KILGOBBIN ROAD, STEPASIDE, CO. DUBLIN

PLANNING LANDSCAPE STRATEGY

LRD OPINION RESPONSE

▲ PL-102 Proposed Site Taken in Charge Area Plan prepared by Downey Architecture & Planning

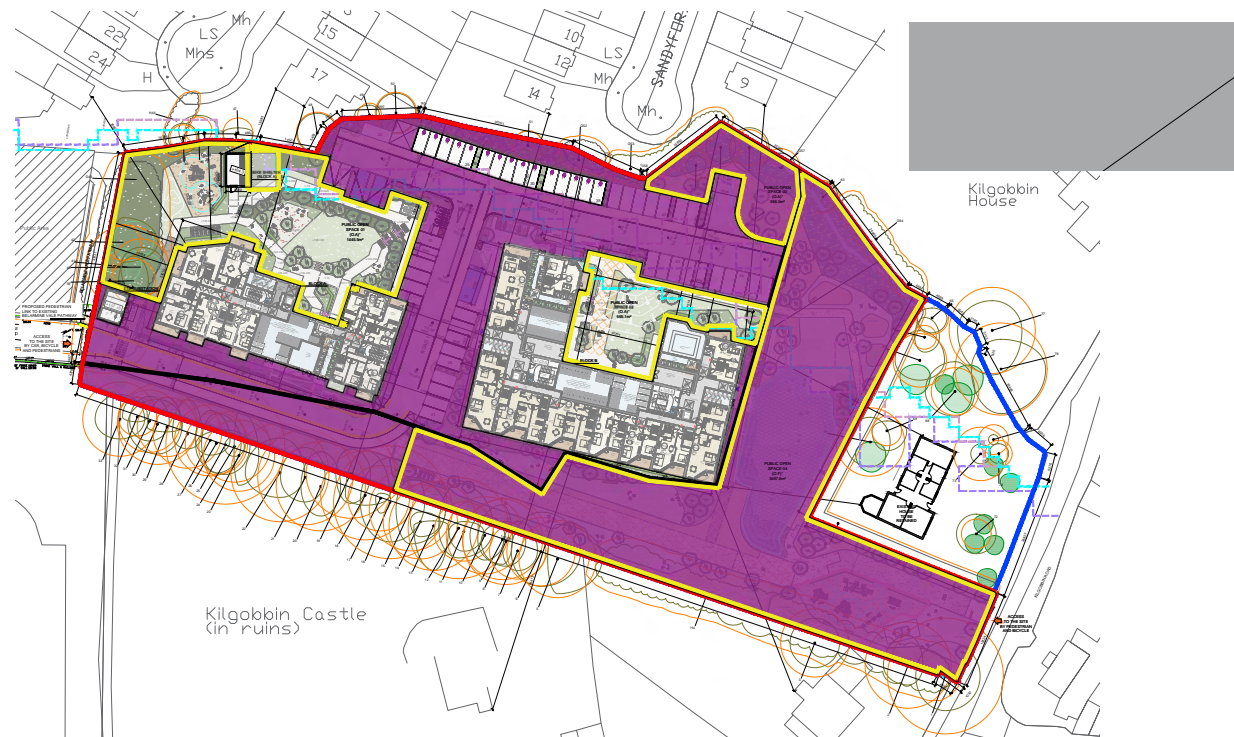
All areas to be designated as public open space must be capable of being taken in charge as per Section 12.8.3.1 of the County Development Plan.

The Applicant shall also confirm the full extent of any areas that are proposed to be taken in charge on a specific plan drawing or drawings, as applicable.

All areas designated as public open space have been confirmed as suitable for taking in charge. The architects' team has prepared the taken-in-charge documentation and specific drawings—please refer to their Statement and Taken-in-Charge drawing for full details.
